Comments for Corrections in IEEE Draft P802.3bp / D0.40, 2 July 2014

Bert Bergner / TE Connectivity

10th July 2014

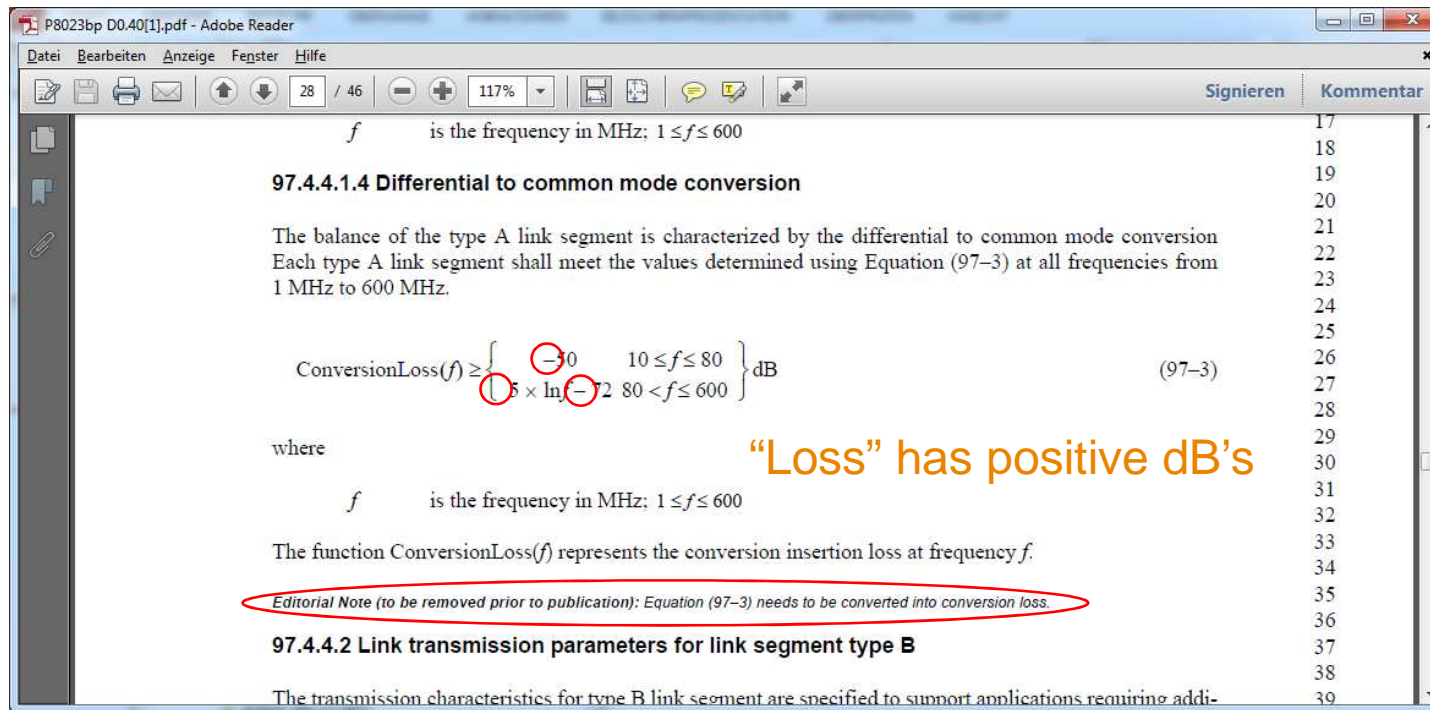
Correction:

$$ConversionLoss(f) \geq \begin{cases} 50 & 10 \leq f \leq 80 \\ 72 - 5 \ln(f) & 80 < f \leq 600 \end{cases} dB$$

Recommendation: → convert *ln* to *log* to be consistent with all other equations

$$5 \cdot \ln(f) = 5 \cdot \ln(10) \cdot \log(f) = 11.51 \cdot \log(f)$$

→ resulting equation:

$$ConversionLoss(f) \geq \begin{cases} 50 & 10 \leq f \leq 80 \\ 72 - 11.51 \cdot \log(f) & 80 < f \leq 600 \end{cases} dB$$
